PUD DEVELOPMENT/PRELIMINARY PLAN FOR:  
**HAVEN VALLEY**  
 (LETA DR.) BRADLEY RD/ALTURAS DR.  
 SECURITY, EL PASO COUNTY, COLORADO

PRELIMINARY GRADING PLAN  
 PROJECT NO. 21085-03CSCV  
 DRAWING NO.

# Grading & Erosion Control Plan\_v5.pdf Markup Summary 11-7-2022

**GP01**  
 SHEET: 4 OF 7

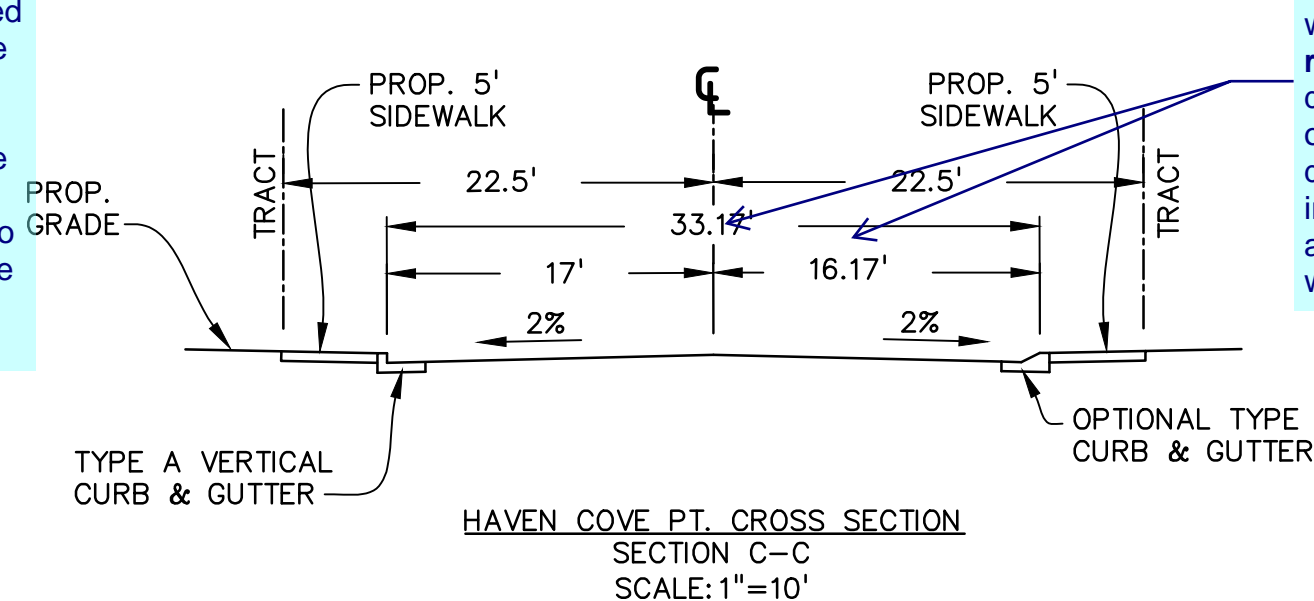
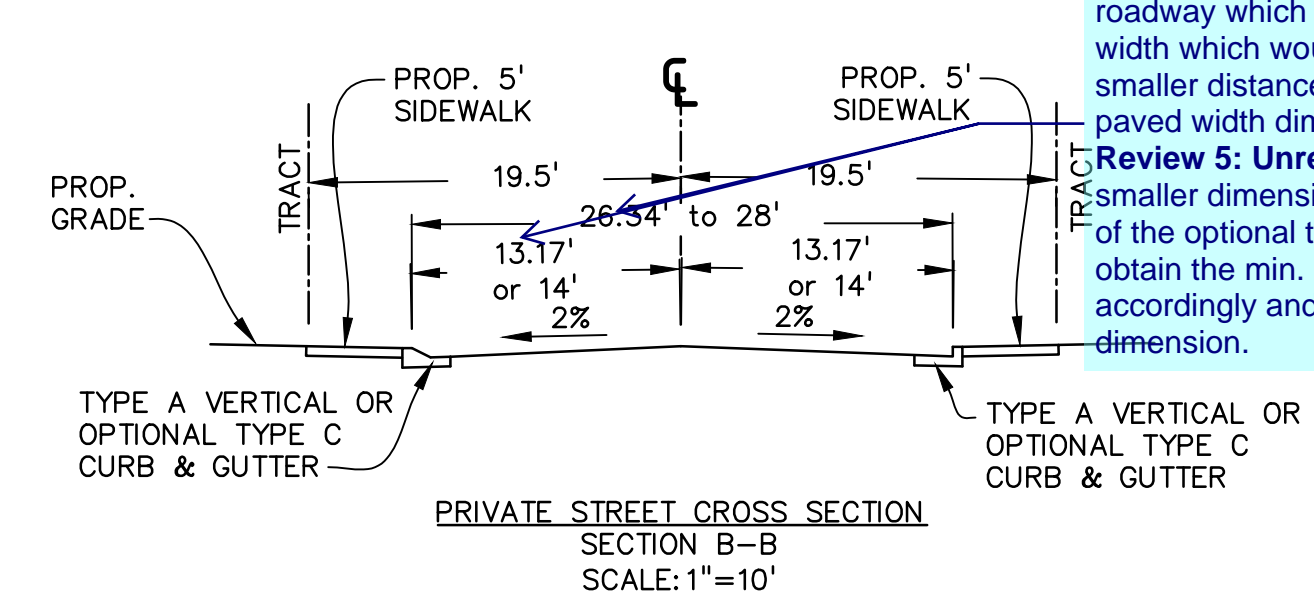
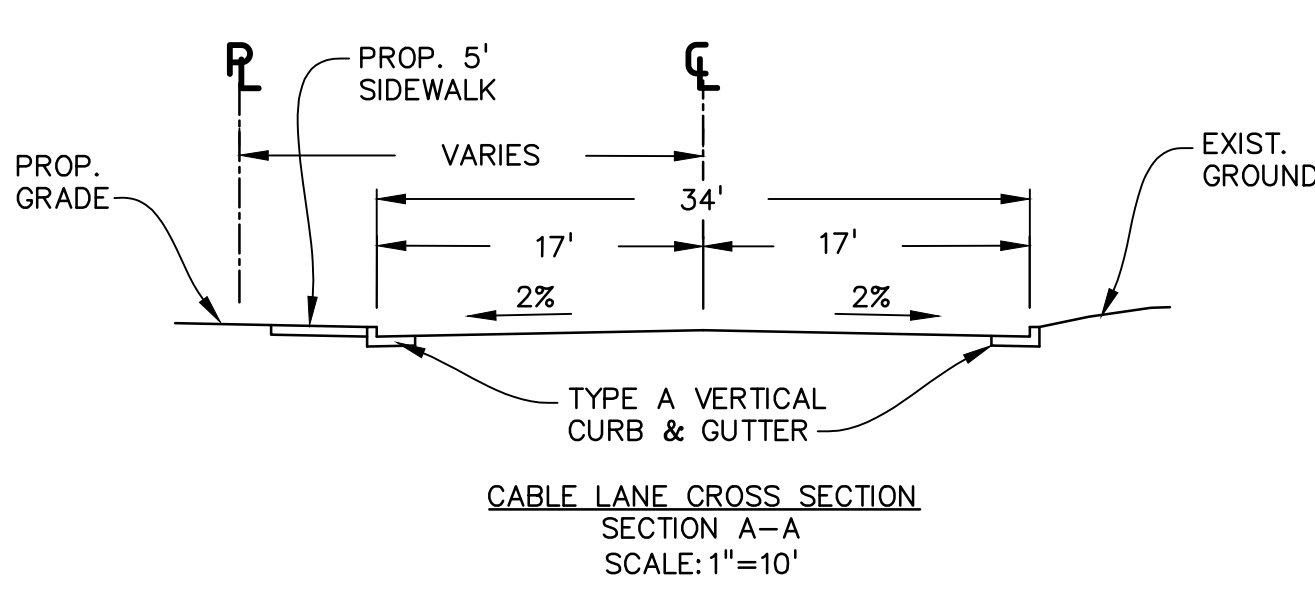
review 4 comment: Please remove the distance shown. The smallest roadway per the PUD and TIS is an urban local low volume roadway which will have a minimum 24' paved width which would not be obtained with these smaller distances. Please also show the paved width dimension  
 Review 5: Unresolved. It appears that these smaller dimensions should be to the flowline of the optional type C curb & gutter in order to obtain the min. 24' paved width, please revise accordingly and label the paved width dimension.

review 4 comment: please revise the distance such that it meets the urban local roadway standards (17.5' to back of curb and 30' min. paved width)  
 review 5: Unresolved. the 16.17' dimension should be to the flow line of the optional type C c/g. The dimension as shown would not result in a 30' paved width. Please revise accordingly and also label the paved width of the roadway.
